UP TO Serial # 15421

7 VALVE ALL-WAVE MODEL.

DIAGRAM OF IMPROVEMENT TO TAW

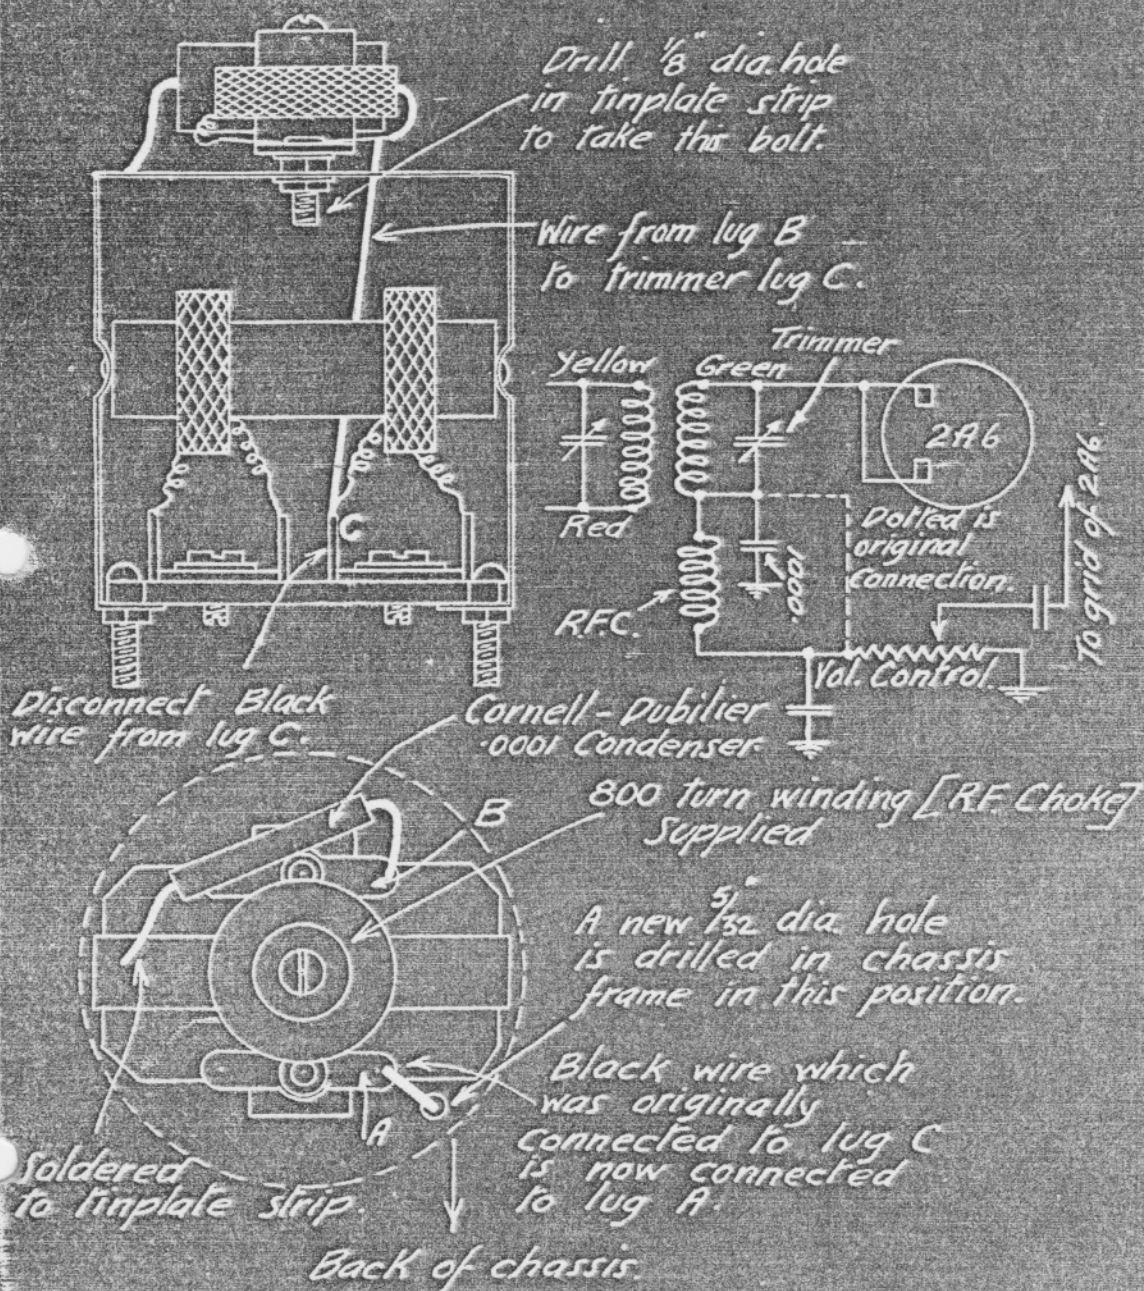
I.F. assembly next to
2A6 valve.

When drilling hole in tinplate strip be sure that the filings do not get between the trimmer plates. In addition to fitting the R.F. Choke and condenser it is advisable to shorten the yellow plate wire of the 2A6 valve so that it becomes almost stretched between the lug on the socket and the anchor point to which the 100,000 ω plate resistor is connected. The yellow wire should not be closer than $\frac{1}{2}$ " to from the green wire and the diode plate lugs on the socket.
